DEPARTMENT OF THE TREASURY
BUREAU OF ALCOHOL, TOBACCO AND FIREARMS
WASHINGTON, DC 20226

E:CE:F:TE:RLB
3311

This is in response to your letter of recent date, to the Bureau of Alcohol, Tobacco and Firearms (ATF). In your letter, you request classification of a device which you have designed to work on your semiautomatic firearms. You have also submitted a sample of the device for our examination.

mini 14
M1 Carbine
SKS

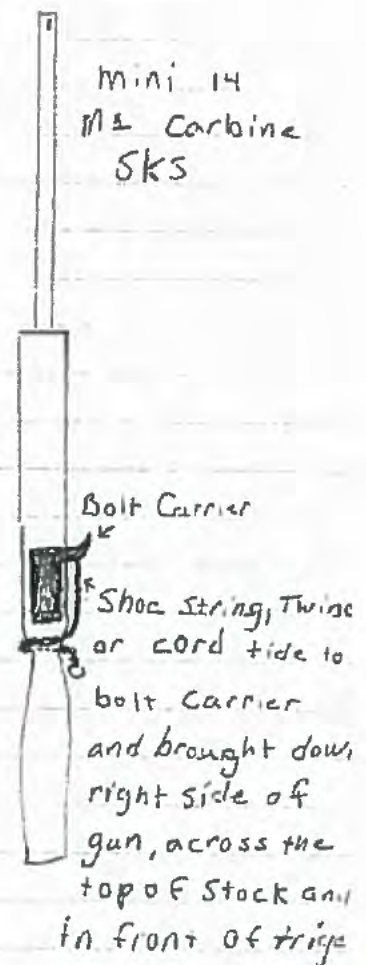
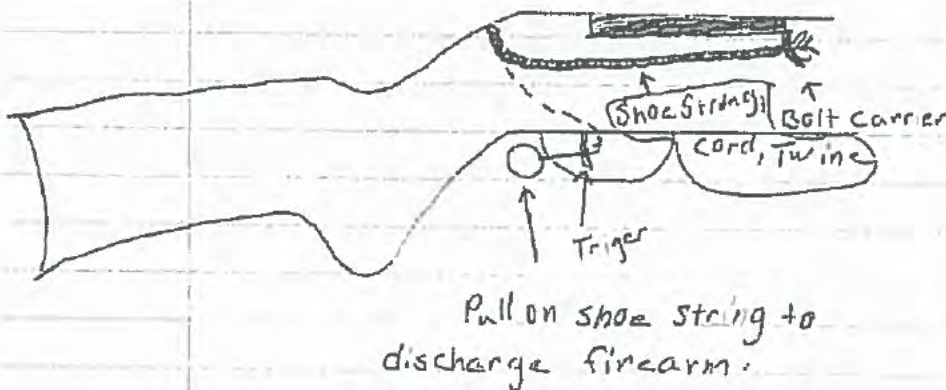
Please advise me as to the legality of use of this
on my fire arms. I have sent a sample.

ATF has previously examined similar devices and determined that they are auxiliary trigger mechanisms which are designed and intended for use in converting a semiautomatic rifle into a machinegun; therefore, they are machineguns as defined in § 5845(b). Based upon our examination of the submitted device and the information you provided, it is our opinion that the sample device is also an auxiliary trigger mechanism and a "machinegun" as defined in the third paragraph of this letter.

It is unlawful for anyone to make, possess, or transfer a machinegun which is not registered in accordance with the provisions of the NFA. Since we are unable to establish that the submitted sample was manufactured and transferred in accordance the provisions of the NFA and § 922(o), we are unable to return it to you, as submitted. However, we can return your shoe string without the loops.

Figures 1, 2, and 3 (attached) illustrate the following points in the firing sequence in the new firearm:

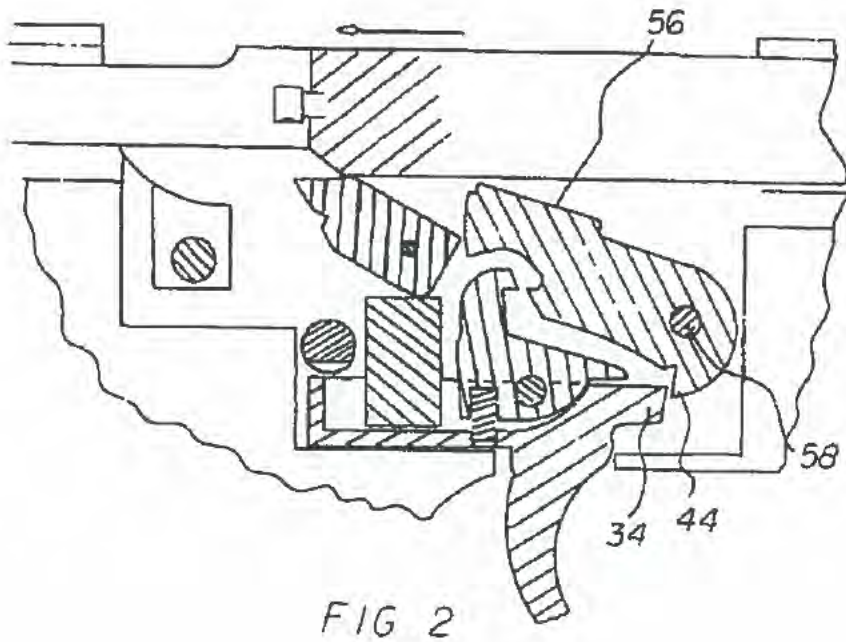
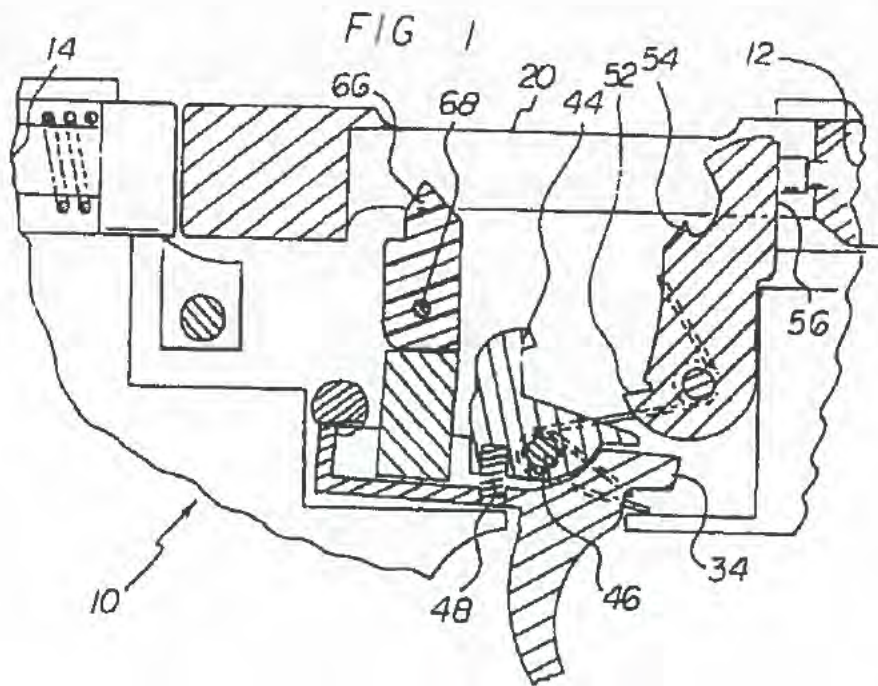
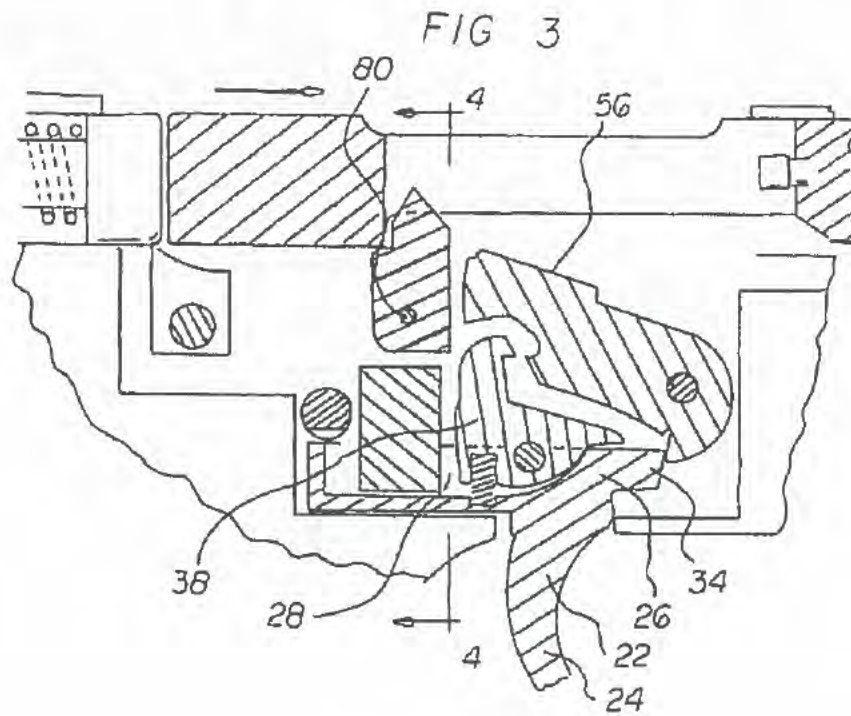
Based on a careful review of your sample and plans, including the illustrations, FTB has determined that the submitted firearm is a "machinegun," being capable of firing automatically with a single function of the trigger. Our Branch reached this finding because it is evident

that from the moment of the application of trigger pressure--and as long as rearward pressure is applied to the trigger--the firearm continues to fire until the firing finger is removed; this firing takes place regardless of the cam's pushing the trigger forward.

Figure 1 – MAK90 with selected parts identified

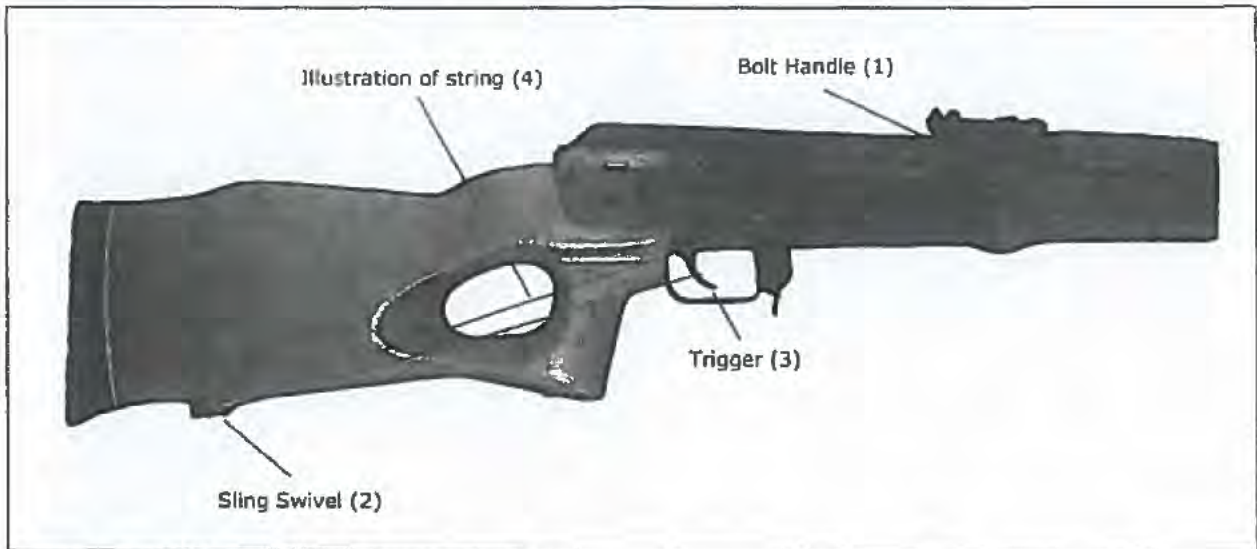
I have these questions regarding the "string trick":

1. Is an appropriate string, tied in the correct manner to be so attached to a semi-automatic MAK90/AK47, a firearm in and of itself?
2. Is an appropriate string, tied in the correct manner to be so attached to a semi-automatic MAK90/AK47, a machine gun?
3. Is the string, so assembled in combination with a semi-automatic MAK90/AK47, effecting the method of operation herein described, a machine gun?
4. Does the fact that the string trick exists affect the semi-automatic classification of MAK90/AK47 firearms in general? I.e. does the fact that a MAK90 can be made to empty its magazine by the addition of a piece of string affect the semi-automatic classification of MAK90's?
